RE: ENGINEER'S CERTIFICATION FOR WILLOW WOOD SUBDIVISION UNIT 5, (L21/D37A2) SUBMITTED FOR RELEASE OF FINANCIAL GUARANTEES, ENGINEER'S STAMP DATED 3/6/97.

RE: WILLOW WOOD SUBDIVISION, UNIT 5
GRADING AND DRAINAGE CERTIFICATION Drainage File L21/D37

RE: WILLOW WOOD, UNIT 5 - DRAINAGE REPORT COMMENTS

SIDEYARD GRADING DETAIL

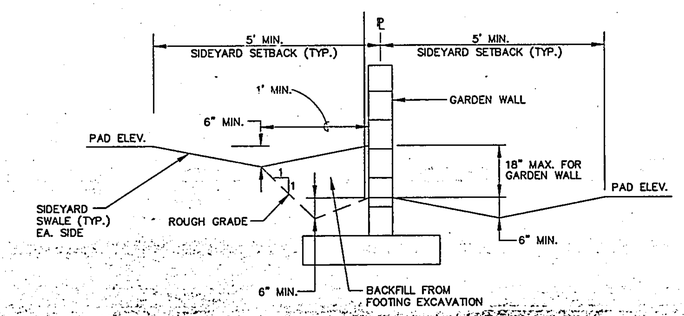
Note 1 of the Erosion Control Plan states that "slopes shall not exceed 4:1". The swales in the Sideyard Grading Detail require a 2:1 slope. Also this detail must indicate the condition that the Engineer will certify.

We have also modified the grading detail to meet the 2:1 max. slope requirement per the DPM. This is an interim condition until permanent sideyard walls are constructed.

QUADRUPLE "C" MODIFIED CATCH BASIN △1

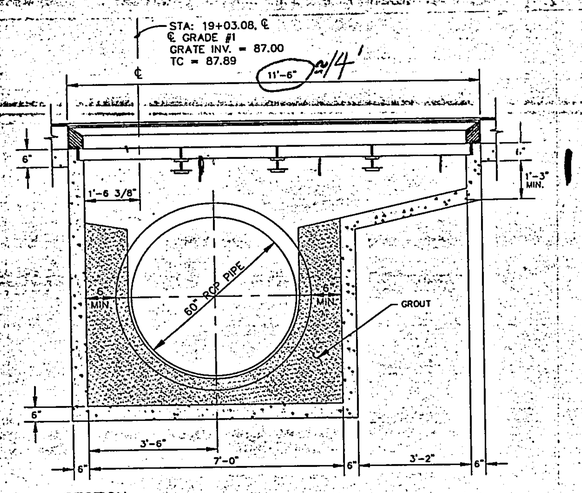
Comment: The geometry and dimensions shown on the construction plans for the sump inlet appear to be incorrect.

Response: Yes, the dimensions shown were incorrect, and have been corrected on the construction plans prior to sign-off by Billy Goolsby. This comment does not affect the drainage report, only the construction plans.

TITLE: WILLOW WOOD – UNIT V
CHIRICAHUA STREET & CHIRICAHUA COURT
STORM DRAIN PLAN AND PROFILE

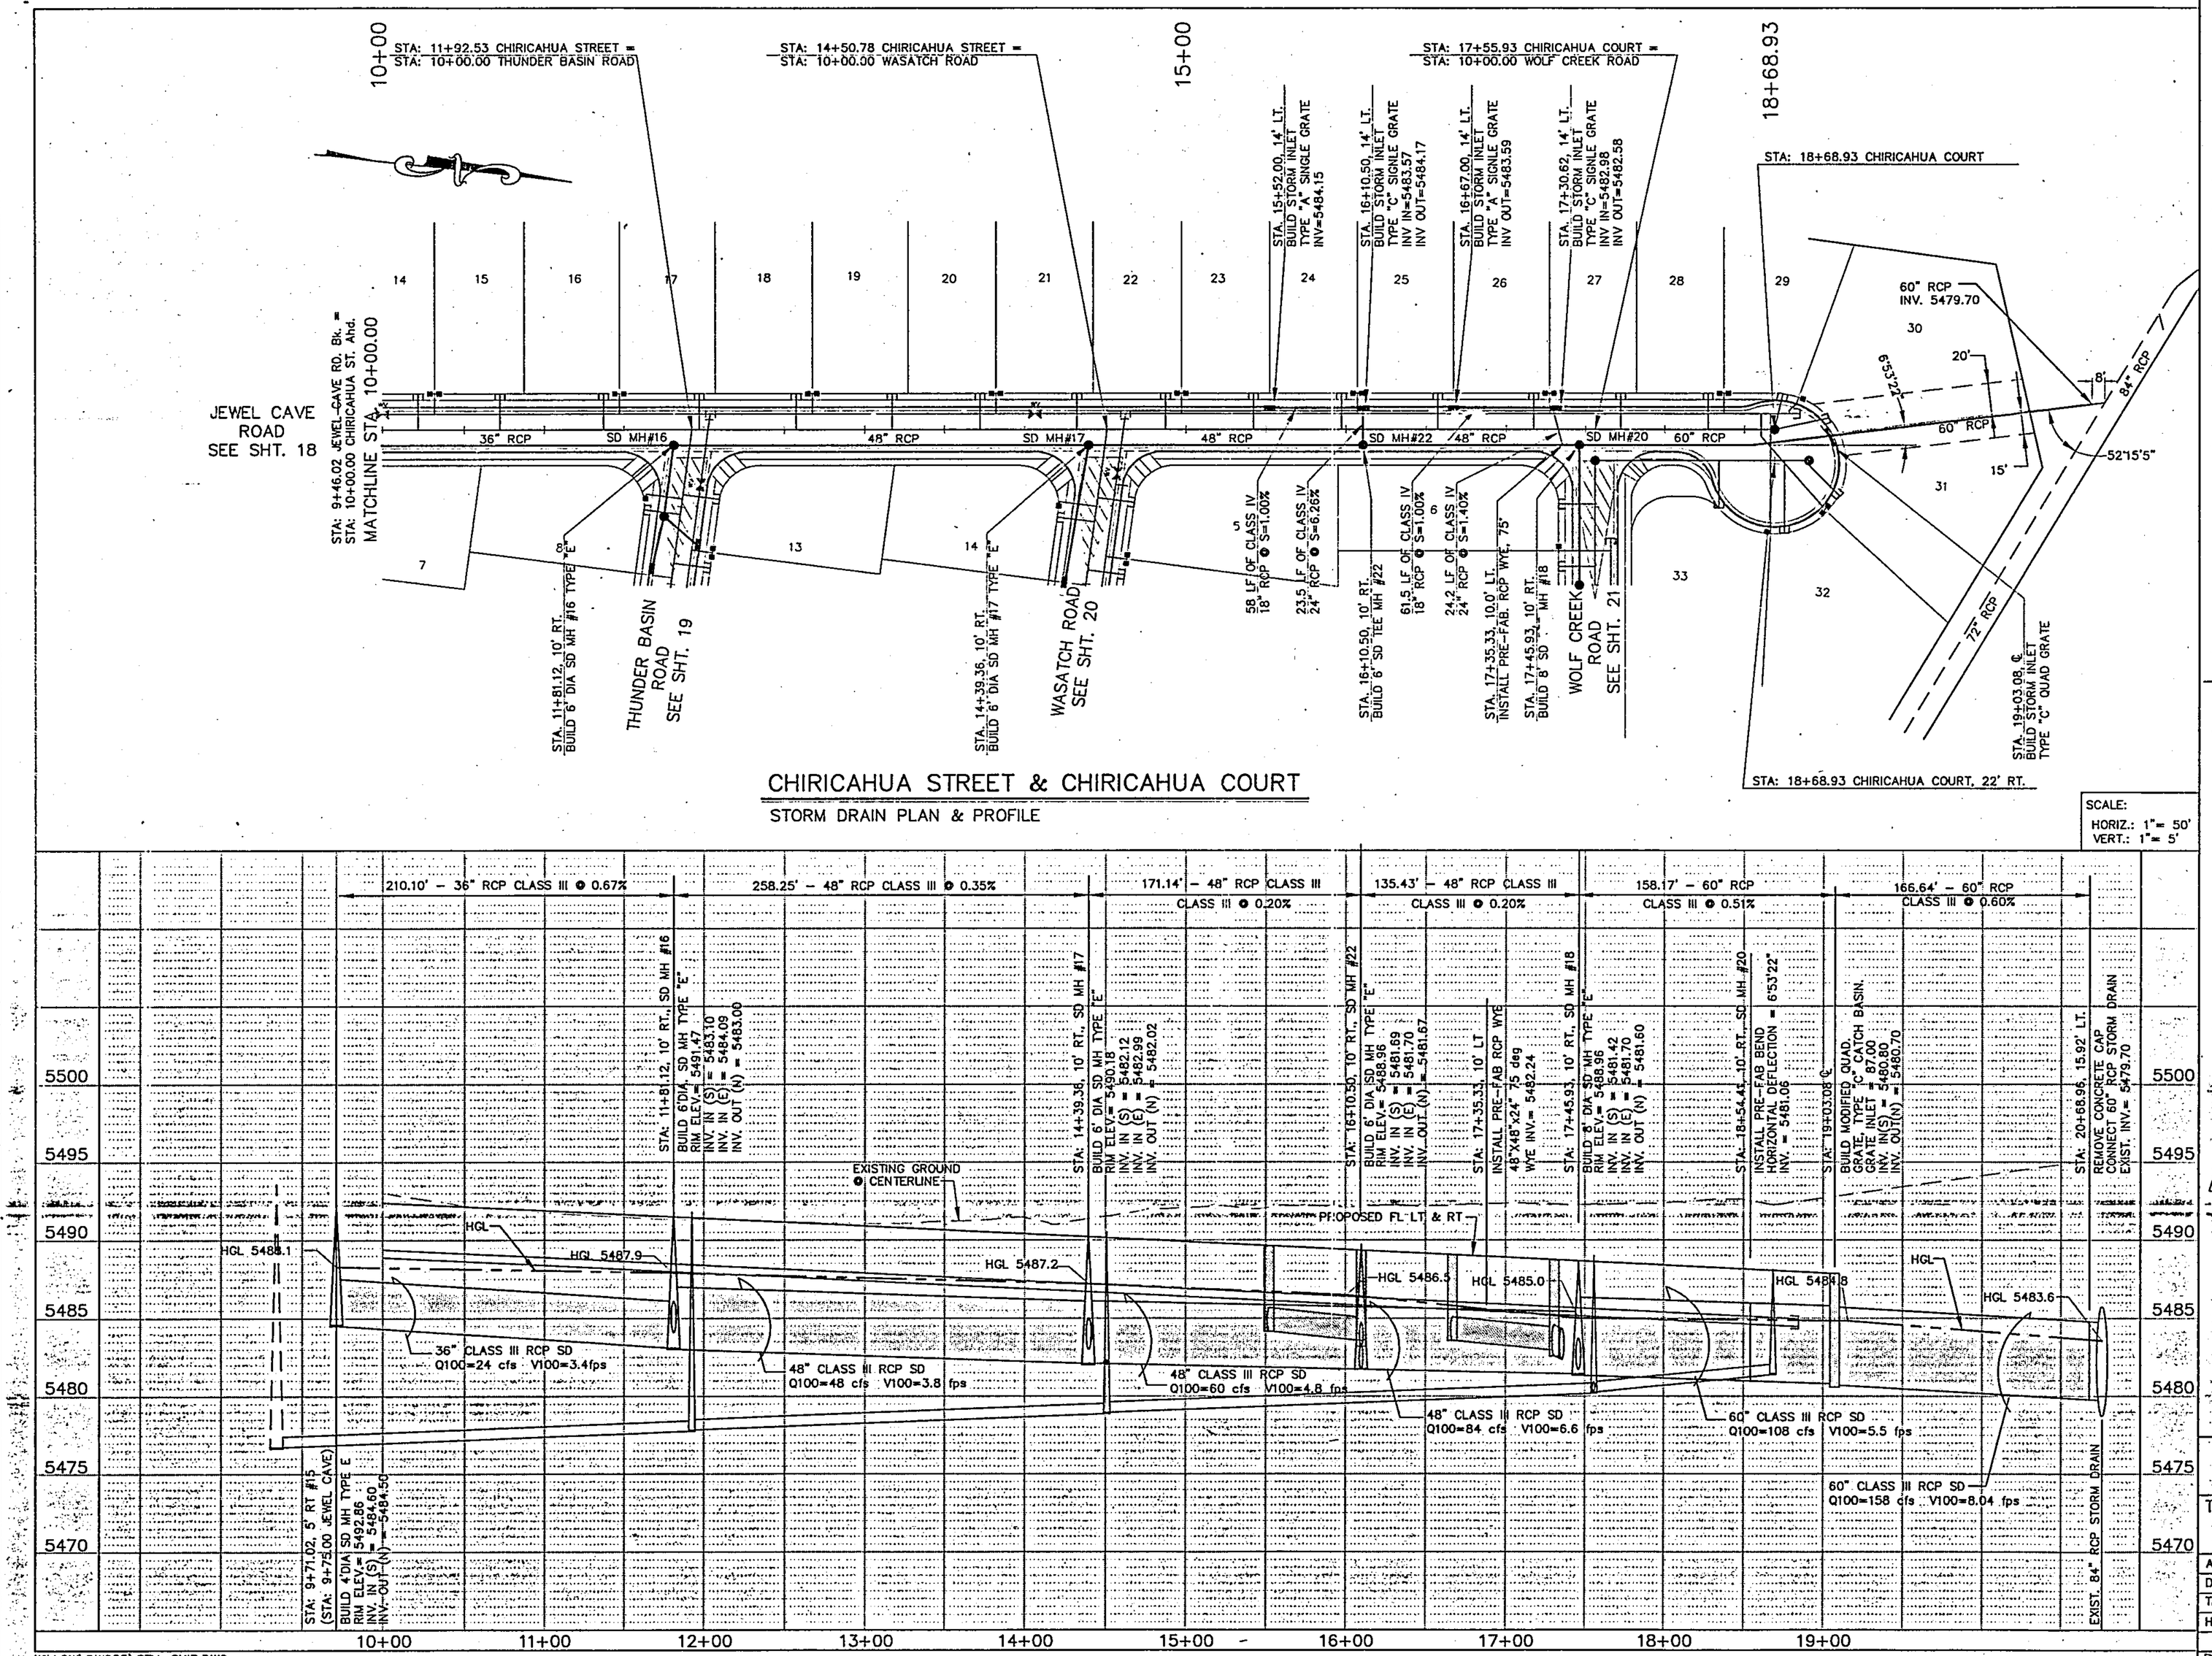
REMARKS: John, our plans for the Chiricahua SD are in conflict with the SAS. I have proposed a field design change which would resolve the conflict. The design has prepared and submitted to the contractor Wednesday for review. Today I submitted the plans to City Survey, Construction and you.

Please review and comment on the revision. I would like to obtain approval without having to go through a DRC review.

I have no objection to the storm drain modifications proposed by Rick Beltramo of AVID. The slow velocities will cause sediment problems but Rick's calculations indicate that it won't be any worse than what was proposed originally.

John: As you requested, I re-ran the HGL spread sheet analysis. The revised geometry only resulted in an in crease of 0.02 ft., very small. I consider this change in the HGL is too small to warrant a revision to the plans or the drainaghe report.

MANHOLE MOVED NORTH 15', to Sta ~17+60.
